## Trinity Islands – Manchester

S73 / MINOR MATERIAL AMENDMENT - SUPPORTING DOCUMENT | AUGUST 2024

Z1-SHP-A180-RP-XX-B5D803 | REVISION P01

### PROPOSED GROUND FLOOR

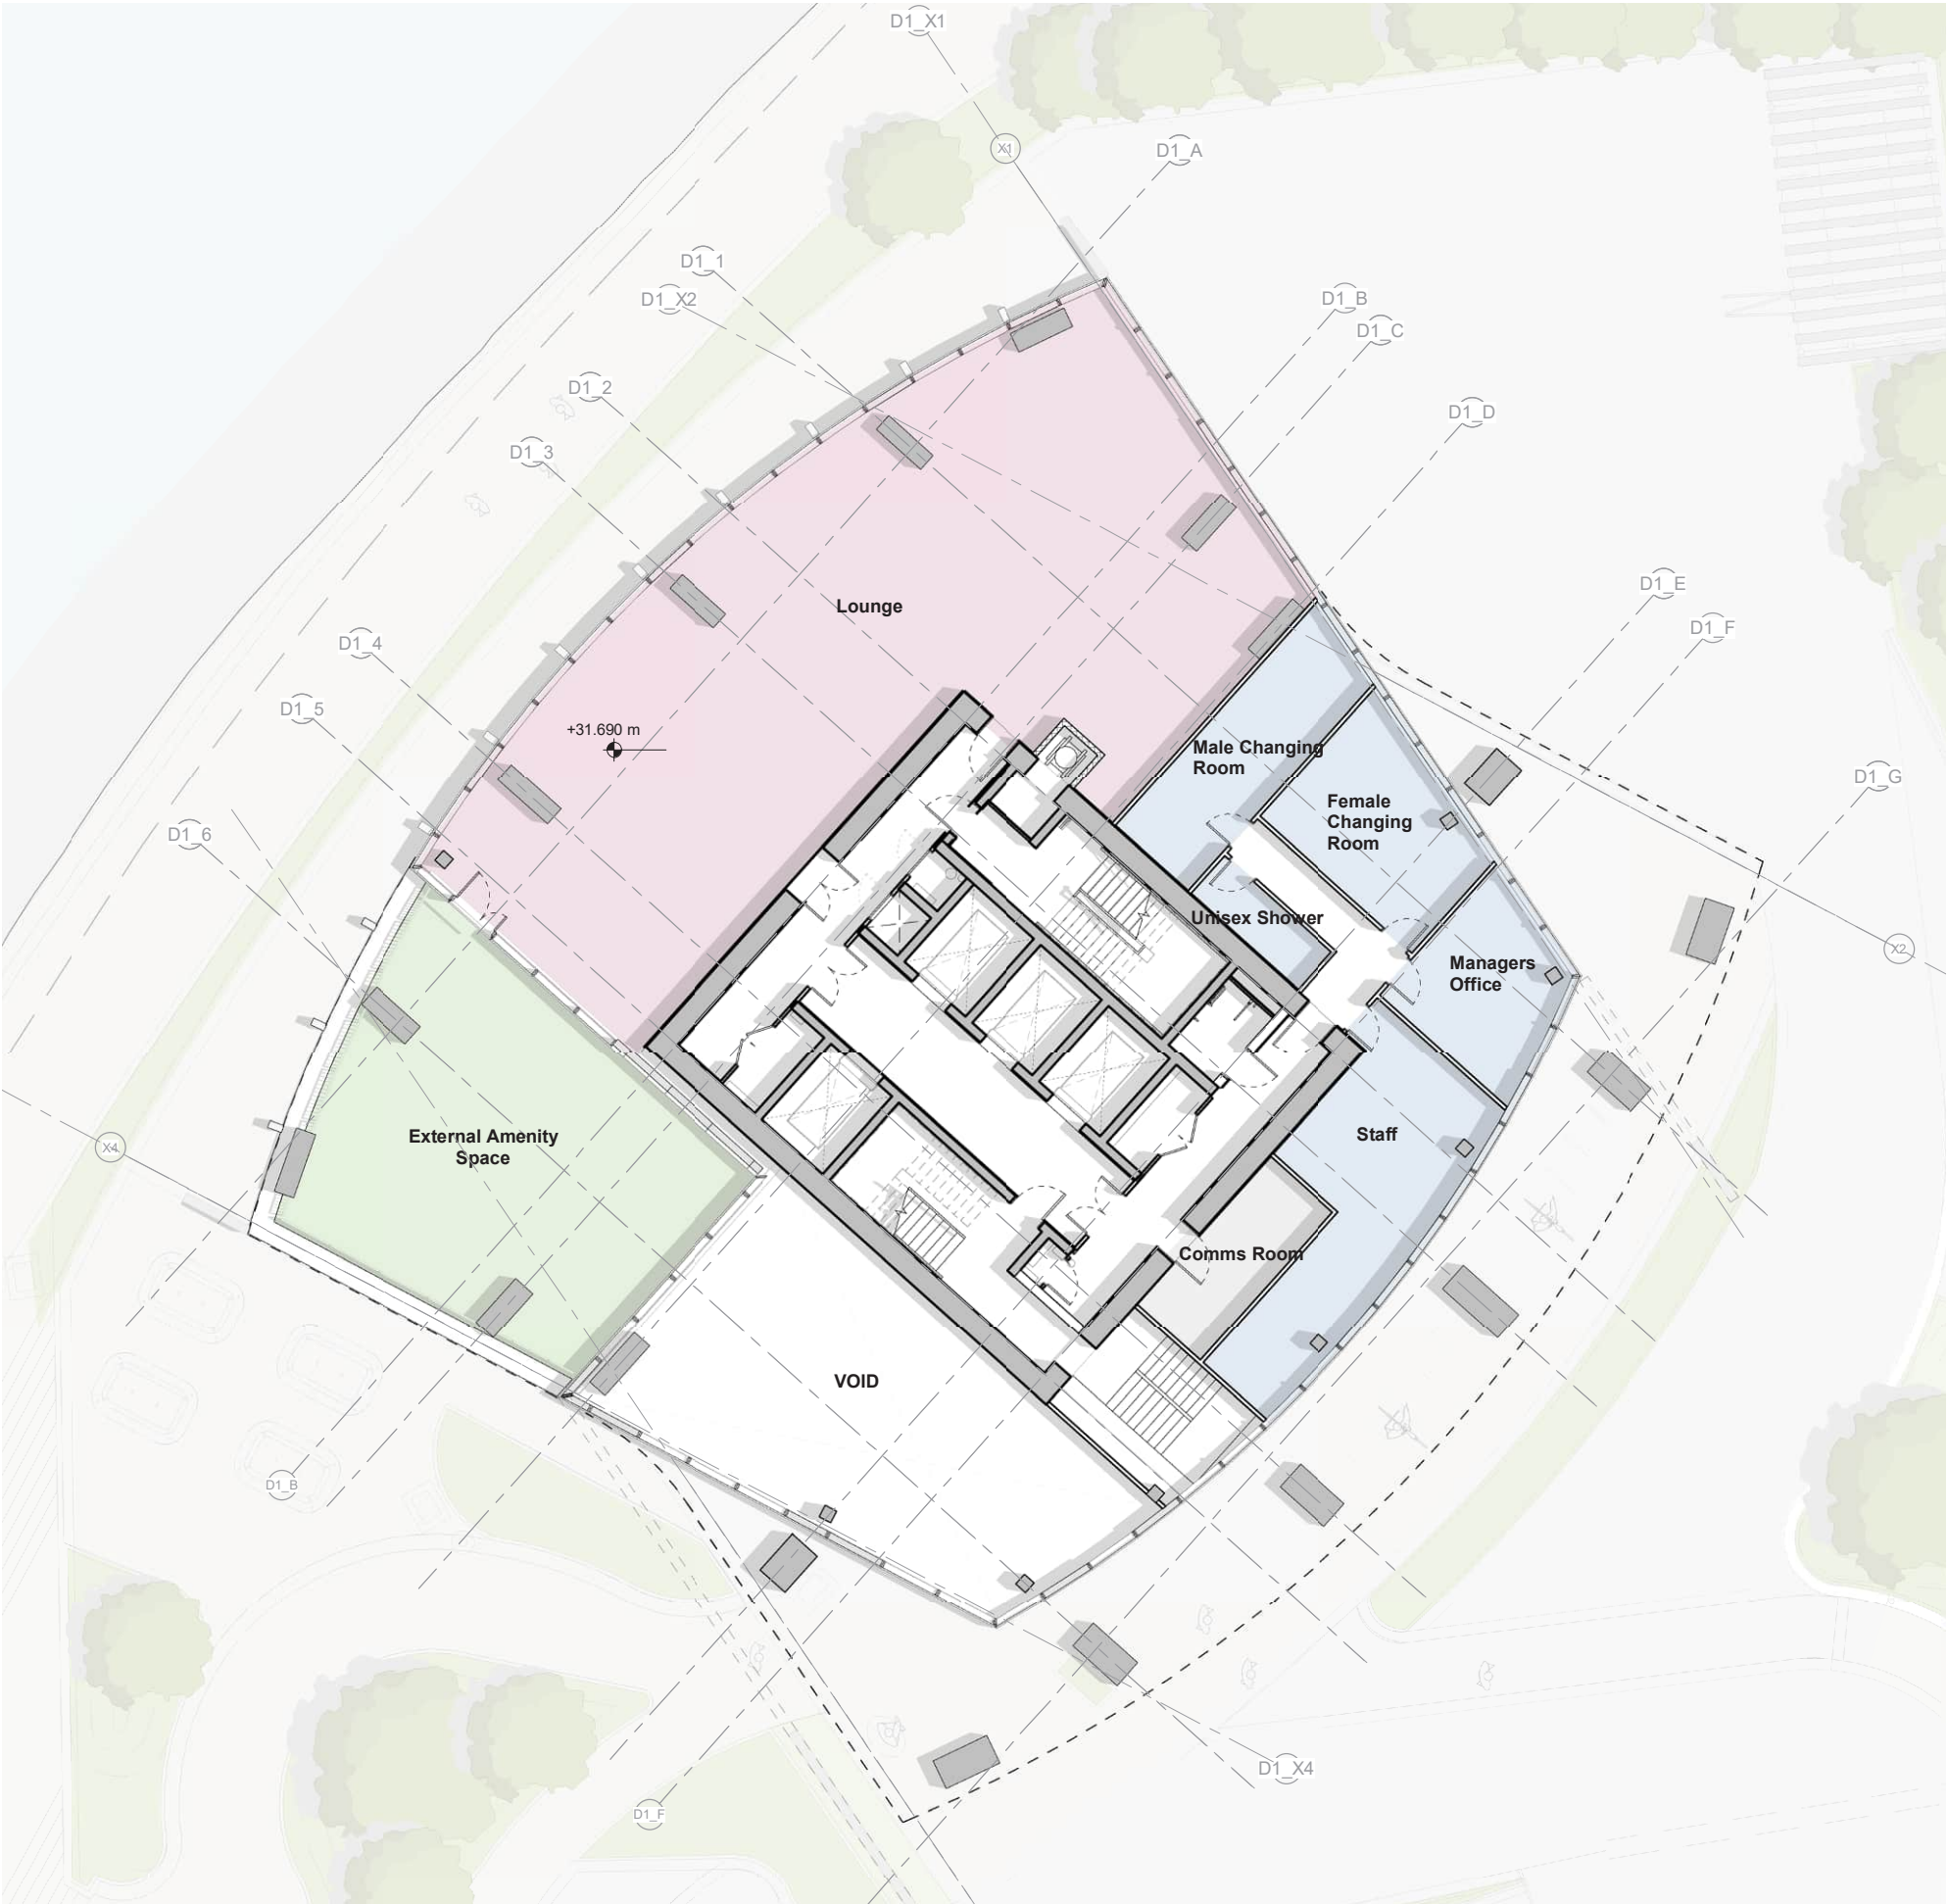
- Building D1 - The updated space planning to the ground floor of D1 seeks to improve the amenity / reception area by providing more space and improved river frontage. This is achieved through relocation of the parcel store to the south east elevation, which can be more easily served by deliveries via the adjacent drop off, and relocation of some of the bins and storage area to the site previously provided for the external life safety generator enclosure (itself relocated into the service area under a preceding NMA Permission Ref: 137663/NMC/2023).

- Minor amendments to the facade include omission of the secondary move in store door and an additional door to the residential foyer in the south west corner of the facade.

- This MMA also requires very minor redistribution of vision glazing and opaque glazed/ louvred panels to the ground and first floor areas to suit the updated space planning and whilst ensuring strong links with the public realm. The amount / area of opaque glass/ louvred panels follows the original design intent ensuring the same high quality facade treatment will be retained. Minor updates to the quantities of the opaque panels are described further in this document (pages 10-11).

- Move in store reduced in size to reflect updated brief.
- Secondary move in store door omitted.
- Refuse store amended to provide improved riverside presence
- Parcel store relocated
- Additional door to entrance foyer/ lounge added
- Minor amendments to distribution of opaque glazing to suit space planning

### PROPOSED SECOND FLOOR

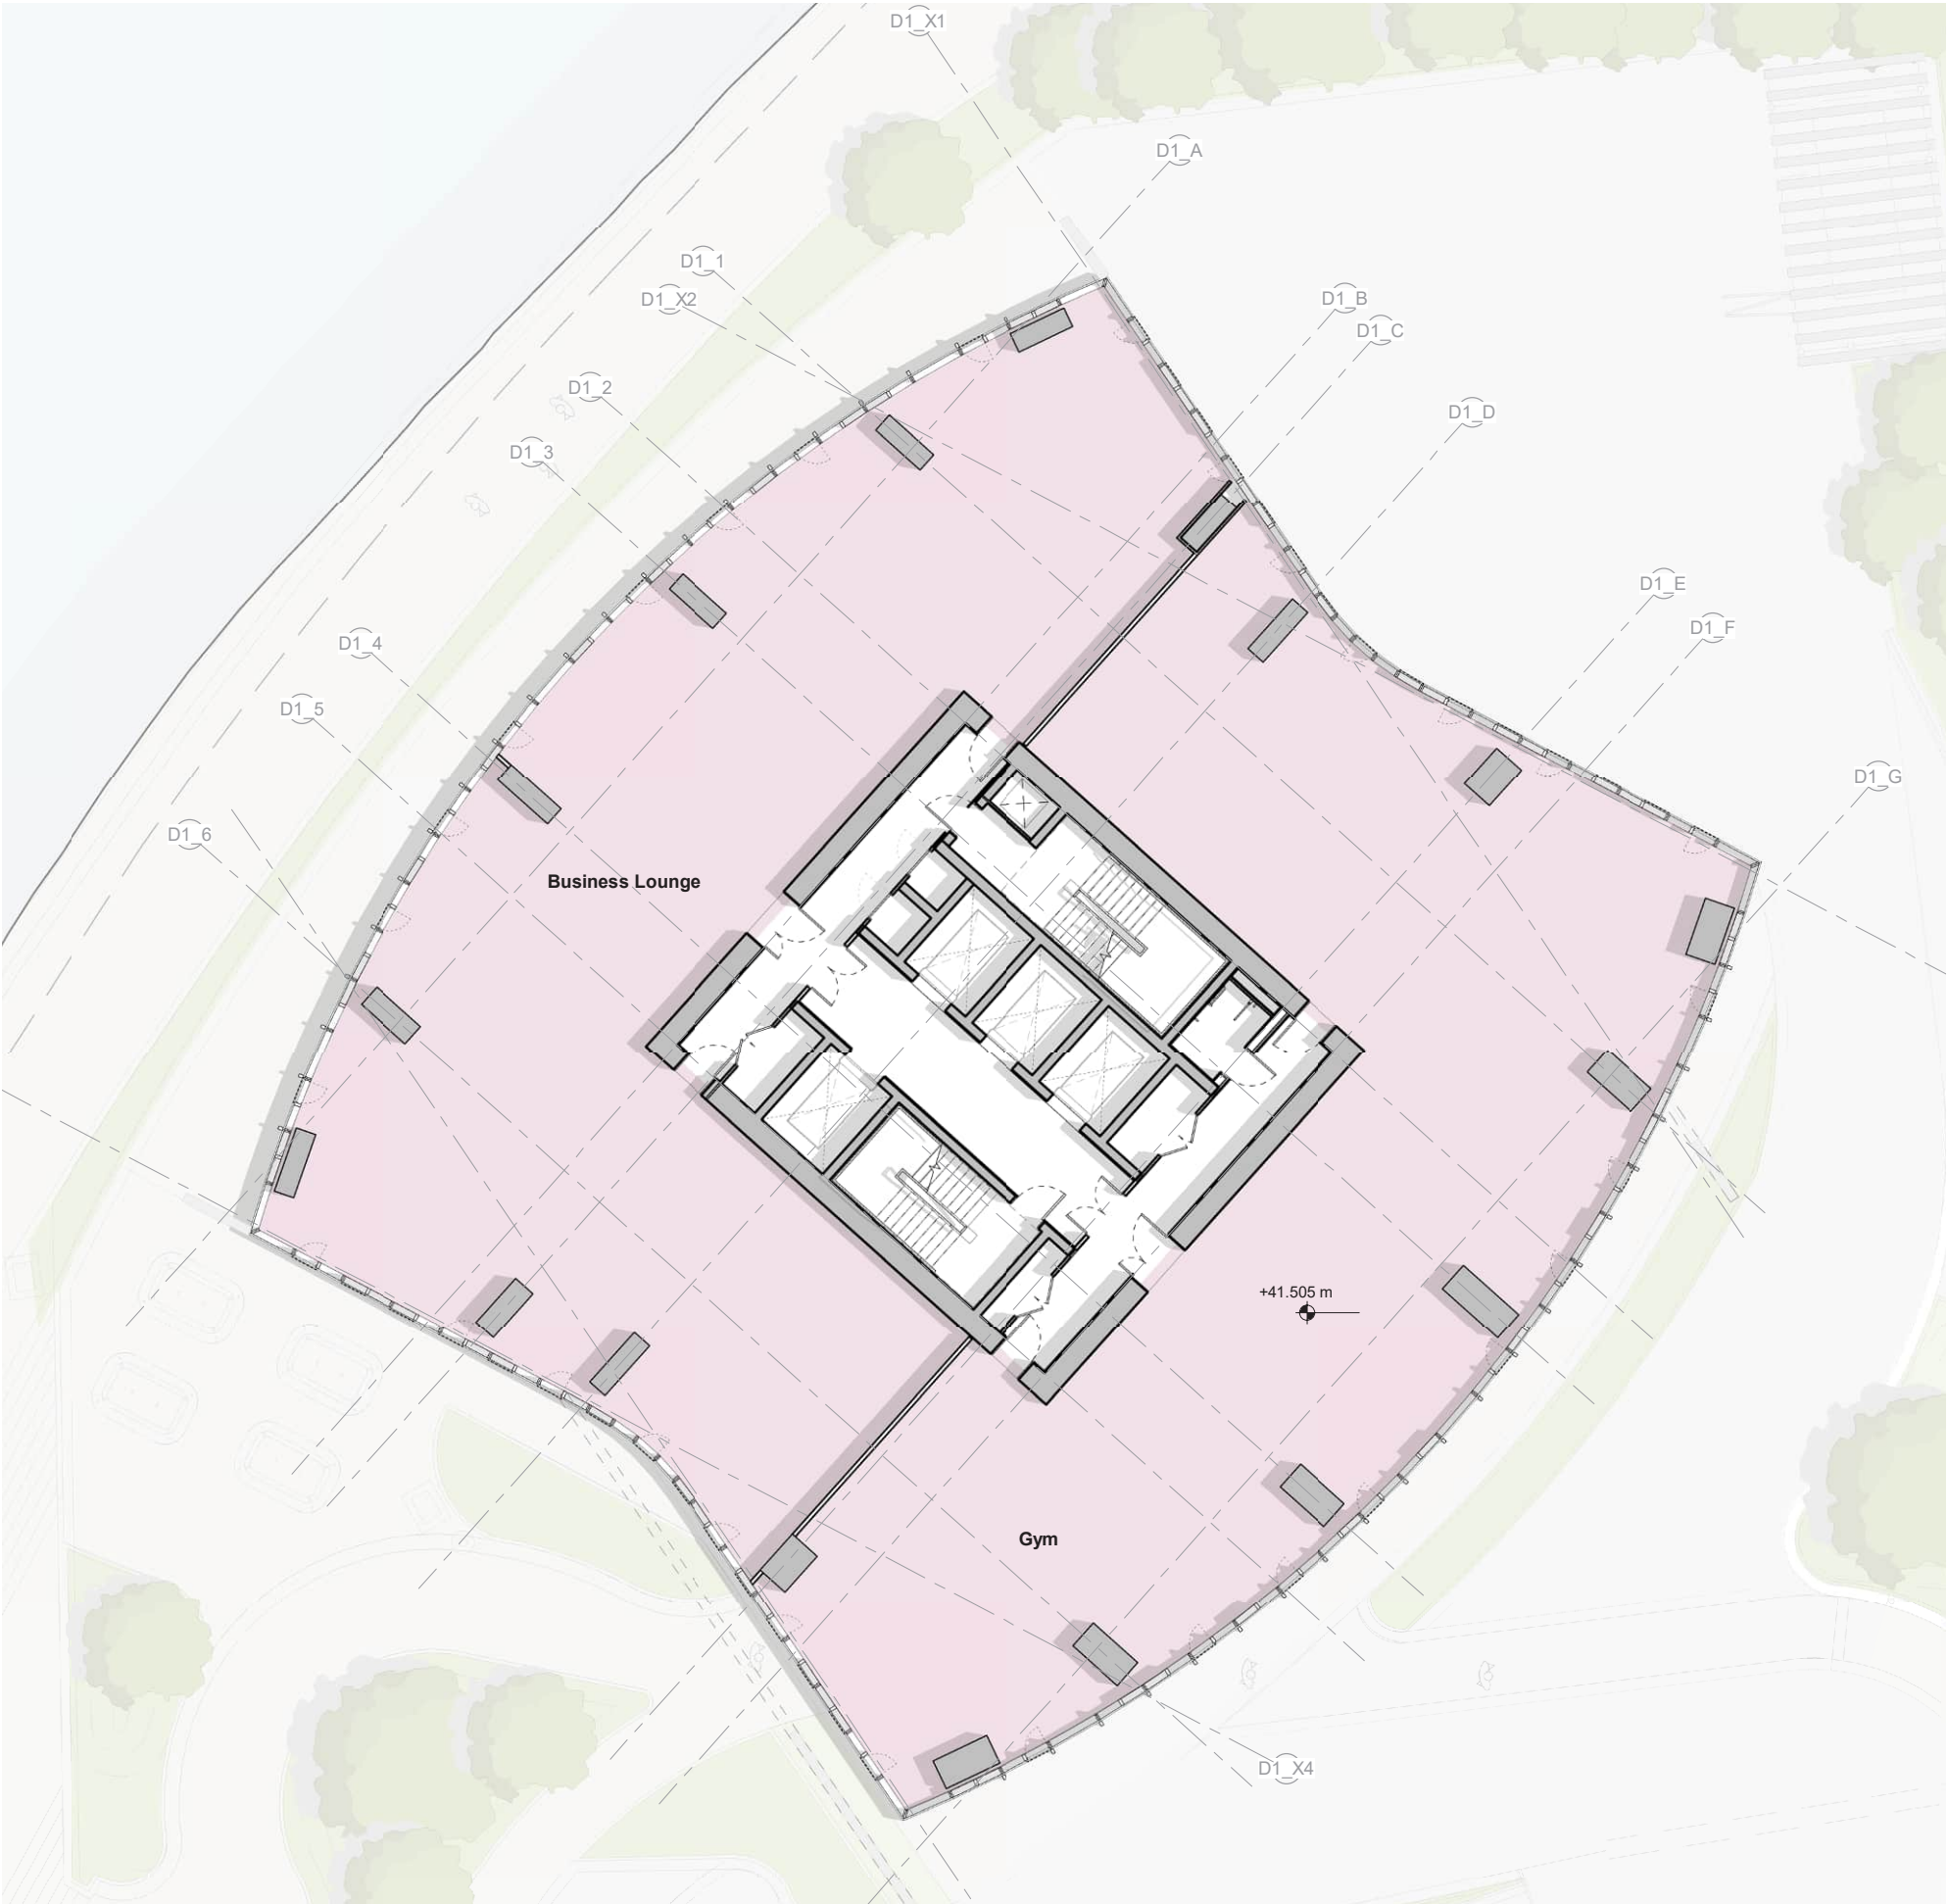
- › Building D1 - The design intent of the second floor external roof terrace remains unchanged. The intention being to use the whole terrace as external residential amenity space, providing external lounge and outdoor gym areas.
